State of California – Natural Resources Agency DEPARTMENT OF FISH AND WILDLIFE South Coast Region 3883 Ruffin Road San Diego, CA 92123 (858) 467-4201 www.wildlife.ca.gov

April 22, 2019

Subject: Comments on the Draft Environmental Impact Report for the Ventura Water Supply Project (SCH# 2017111004), Ventura County

Figure 1: Potential groundwater dependent ecosystems within the Oxnard Basin and the proposed Project areas.

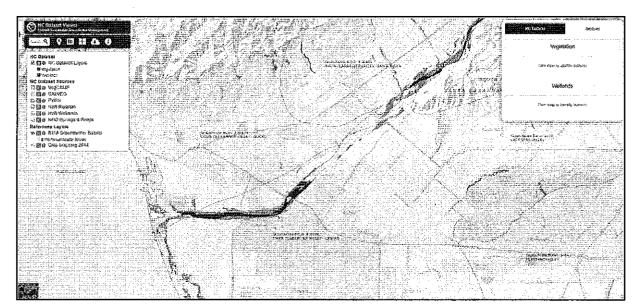
Issue: CDFW has a vested interest in the sustainable management of groundwater, as many sensitive ecosystems and public trust resources are dependent on groundwater. The Oxnard Basin is a critically overdrafted basin (COB). The final EIR should consider and analyze impacts to groundwater dependent ecosystems (GDEs) in the Project.

Why impact would occur: The Department of Water Resources (DWR)'s Natural Communities Commonly Associated with Groundwater Dataset identifies many potential GDEs in the Project's geographic scope (DWR 2019). The potential GDEs identified in orange in Figure 1 of DWR's dataset likely consists of phreatophytic vegetation, which rely on water supply from the groundwater table.

Evidence impact would be significant: Phreatophytic vegetation is a critical contributor to nesting and foraging habitat for a wide range of species and can be affected by depth to groundwater (Naumburg et al. 2005, Froend and Sommer 2010). This sensitivity to groundwater level thresholds means that localized pumping and recharge actions altering groundwater levels, such as those proposed in the Project, can impact the health and extent of phreatophyte vegetation. Both decreasing (drying out) or increasing (drowning) groundwater elevation has the potential to stress phreatophytes depending on the plant species and the groundwater elevation and duration (e.g., short term wetness/dryness versus prolonged wetness/dryness). Proposed groundwater management actions included in the Project should be managed with consideration to impacts to potential GDEs.

Mitigation Measure #1: The final EIR should verify the existence of GDE that could be affected by the Project and identify vegetation communities (e.g., species compositions, structural diversity, and integrity) and associated rooting depths/optimal groundwater table elevations. This will allow Project proponents to: 1) determine which proposed phase or alternative is most likely to impact GDEs based on basin hydrology; 2) deploy representative groundwater monitoring stations within GDEs to track groundwater levels and vegetation responses over time; and, 3) establish thresholds/triggers for adaptive management to respond to stressed vegetation as needed. If the Project is expected to result in habitat benefits to GDE's, monitoring should be utilized to track and confirm positive and negative outcomes.
